**BETTENDORF CITY COUNCIL  
COMMITTEE OF THE WHOLE  
COUNCIL CHAMBERS – CITY HALL**

**TUESDAY, FEBRUARY 17, 2026  
6:15 P.M.**

The City's Standard Specifications and Standard Drawings govern the types of materials, construction methods and other details for all public improvements. These specifications and detail drawings have not been updated in nearly twenty-five (25) years.

Engineering staff has reviewed the specifications manual and created an additional document, the City's Supplemental Specifications, which modify certain SUDAS sections to better reflect our needs. Staff is requesting that the current specifications and detail drawings be replaced with the SUDAS Specifications and the City Supplemental Specifications upon approval of the ordinance, for immediate implementation.

REVISION	1	09-15-25
	BETT6010.520		
	SHEET 1 of 1		
STANDARD ROAD PLAN			
REVISIONS:			
SUDAS DIRECTOR		DESIGN METHODS ENGINEER	
<b>TRIPLE CATCH BASIN</b>

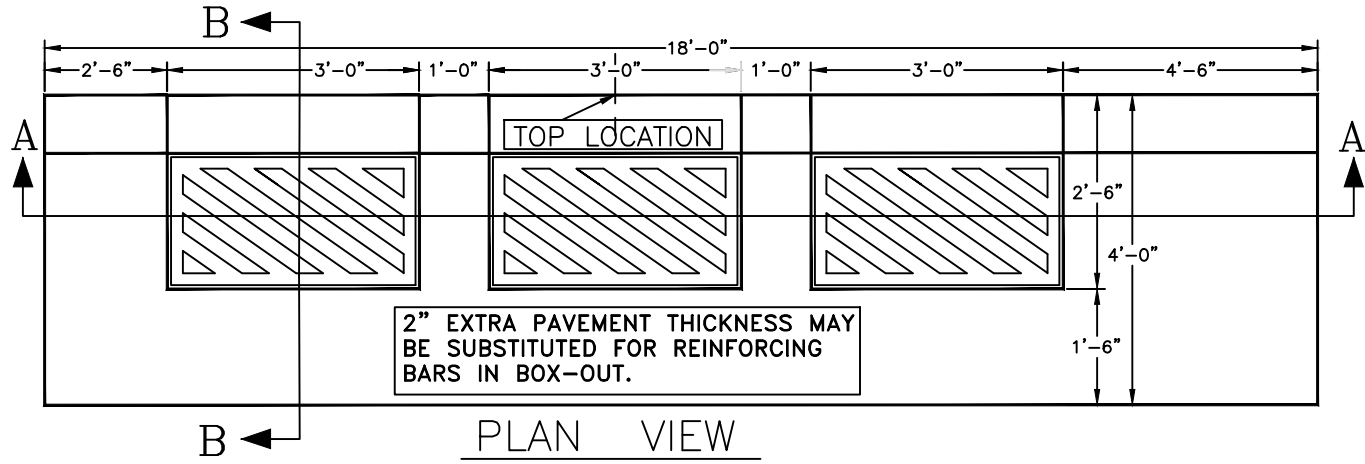
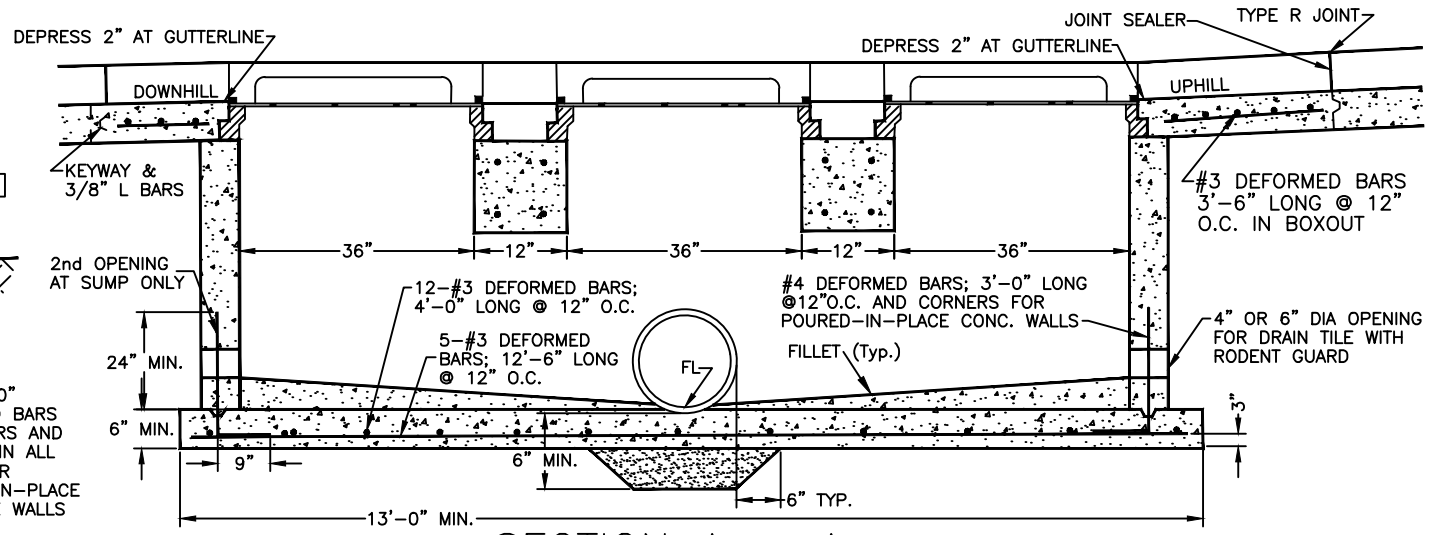
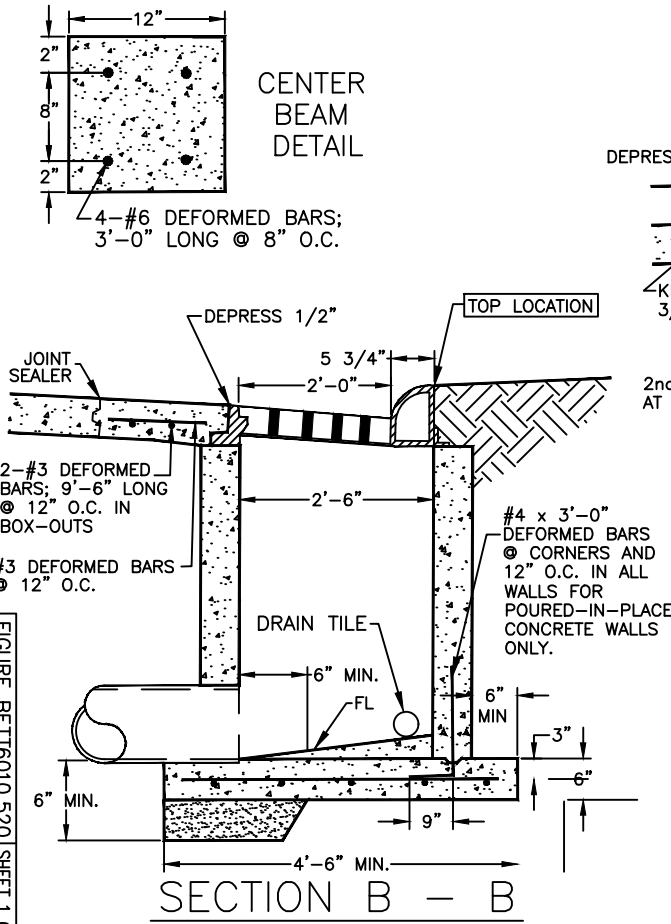
ADD Figure **BETT6010.520**

REVISION
	1 05-23/25
<b>STANDARD ROAD PLAN</b>	BETT7010.102
SHEET 1 of 2	
REVISIONS:	
SUDAS DIRECTOR _____ DESIGN METHODS ENGINEER _____

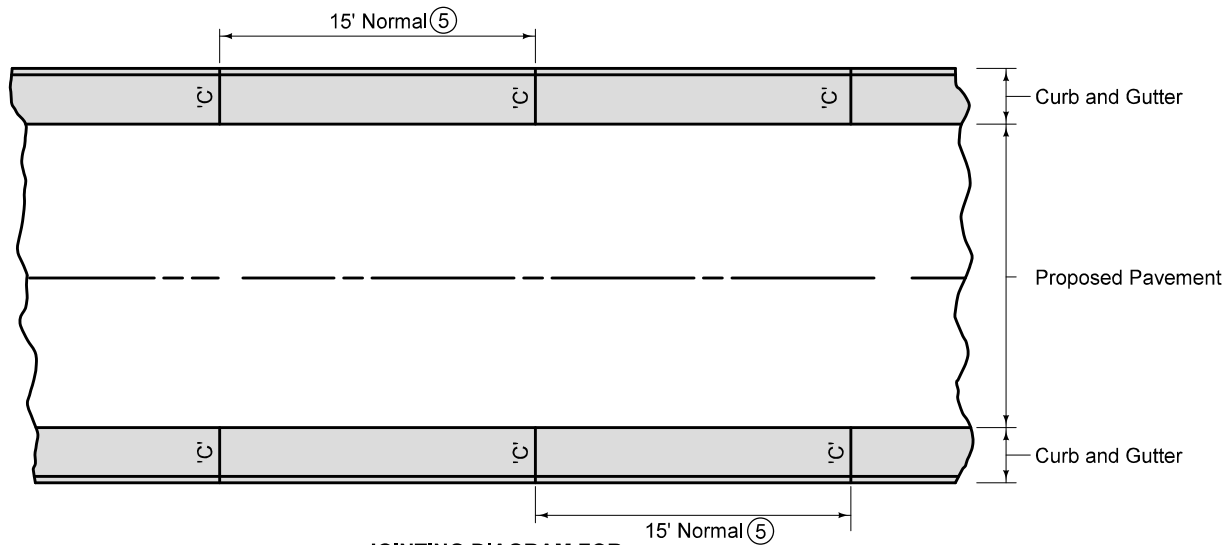
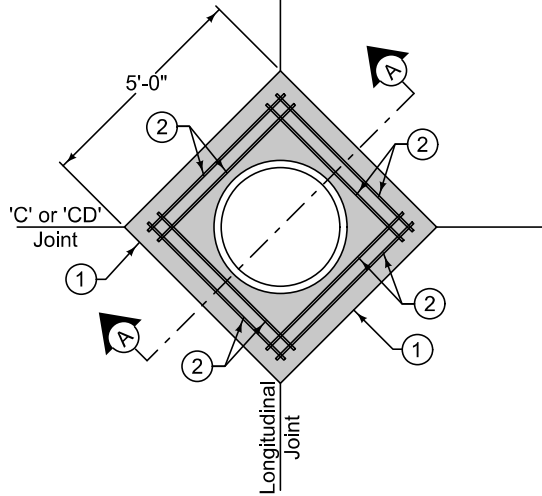
REPLACE Figure 7010.102 with Figure **BETT7010.102**

REVISION	
	1	05-23/25
STANDARD ROAD PLAN		BETT7010.103
		SHEET 1 of 1
REVISIONS:		
SUDAS DIRECTOR _____ DESIGN METHODS ENGINEER _____		
<b>MANHOLE BOXOUTS IN PCC PAVEMENT</b>

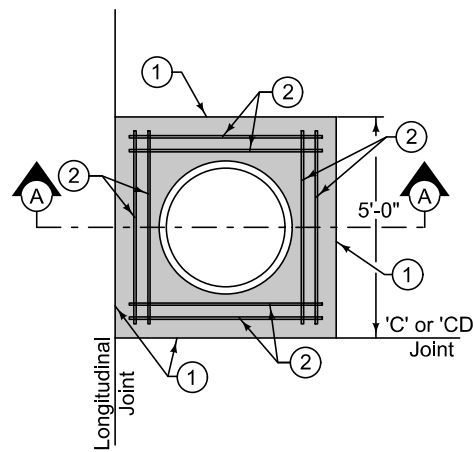
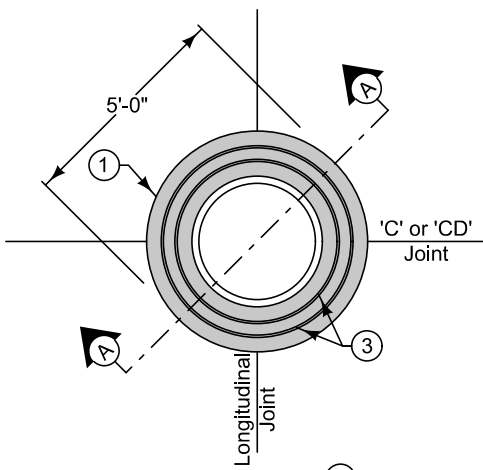
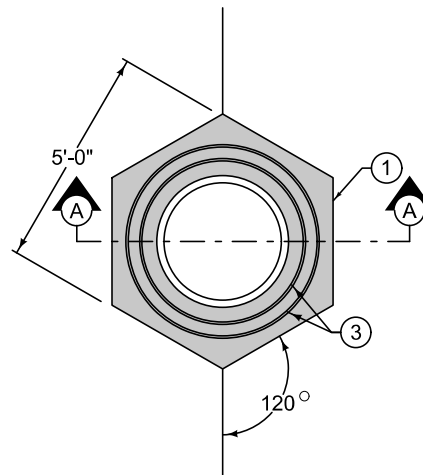
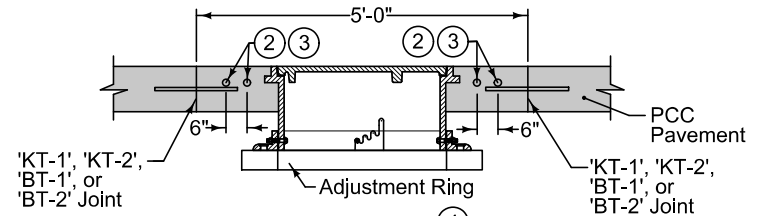
REPLACE Figure 7010.103 with Figure **BETT7010.103**

REVISION
	1 05-23/25
	BETT7010.901
SHEET 1 of 1

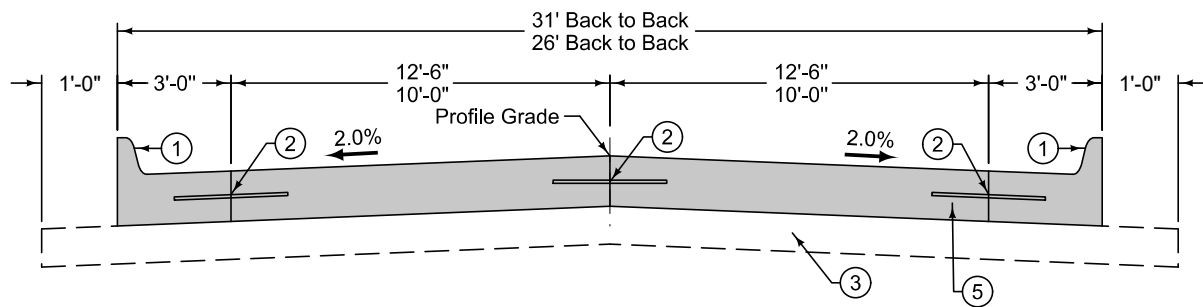
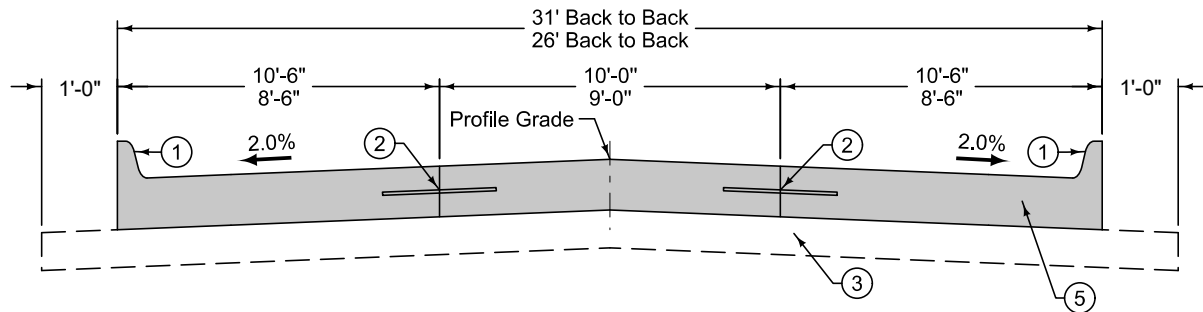
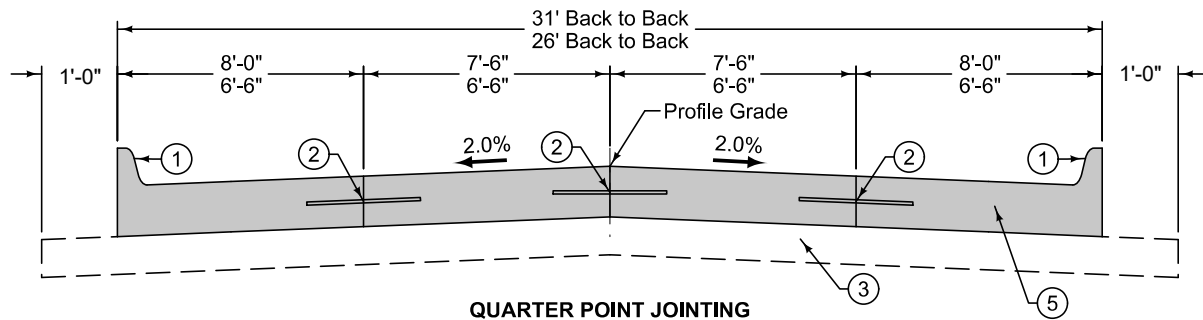
REPLACE Figure 7010.901 with Figure **BETT7010.901**

REVISION
	1 05-23/25
STANDARD ROAD PLAN	BETT7020.201
SHEET 1 of 1	
REVISIONS:	
SUDAS DIRECTOR DESIGN METHODS ENGINEER	
<b>MANHOLE BOXOUTS IN HMA PAVEMENT AND HMA OVERLAYS</b>

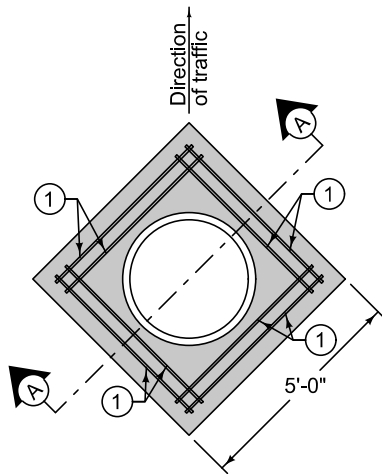
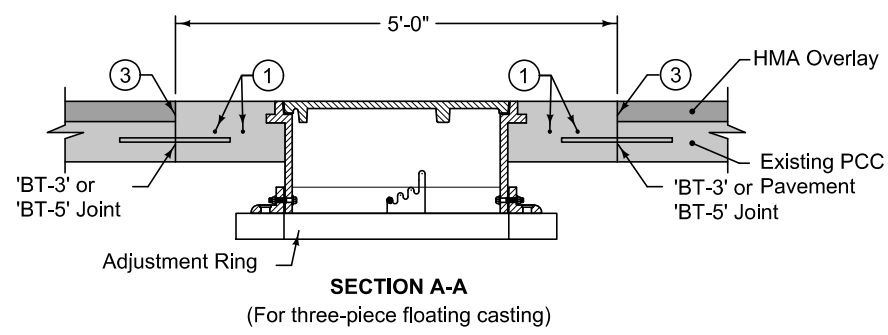
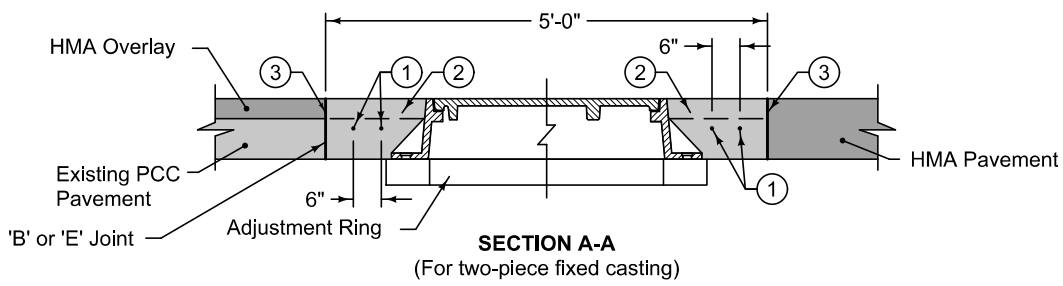
REPLACE Figure 7020.201 with Figure **BETT7020.201**

REVISION	
	1	12-05-25
	BETT7040.101	
SHEET 1 of 1

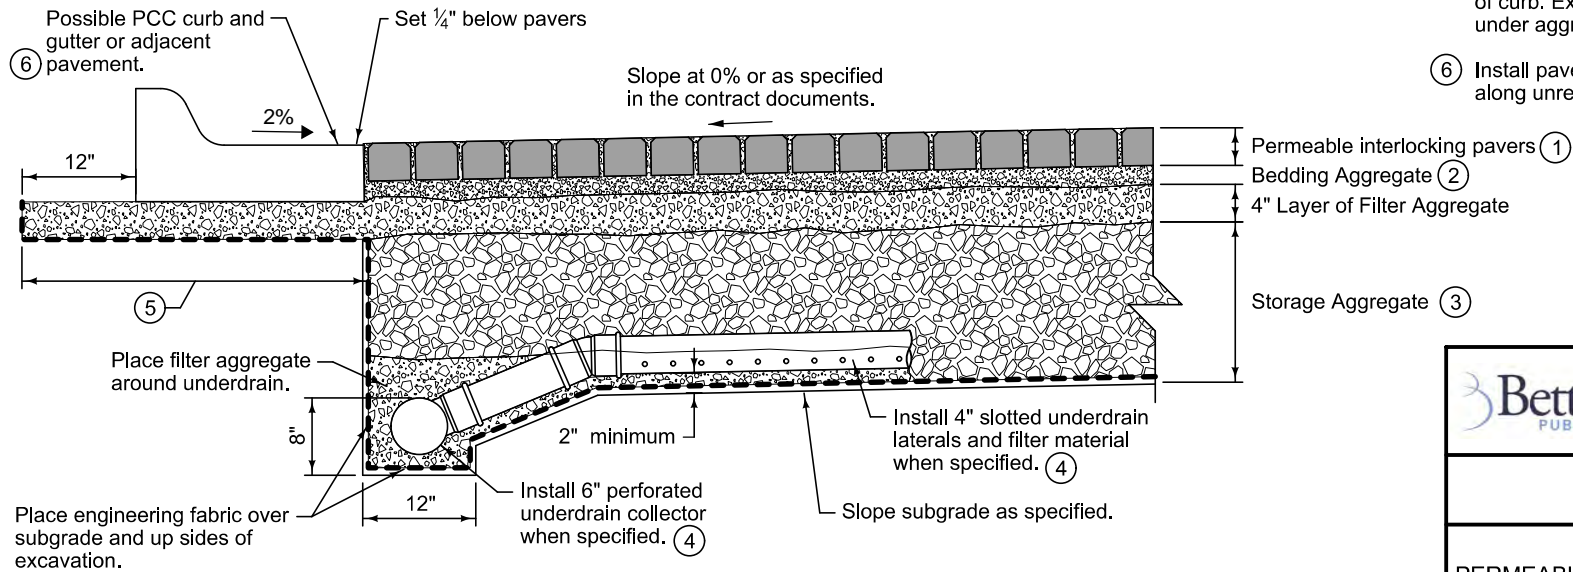
REPLACE Figure 7040.101 with Figure **BETT7040.101**
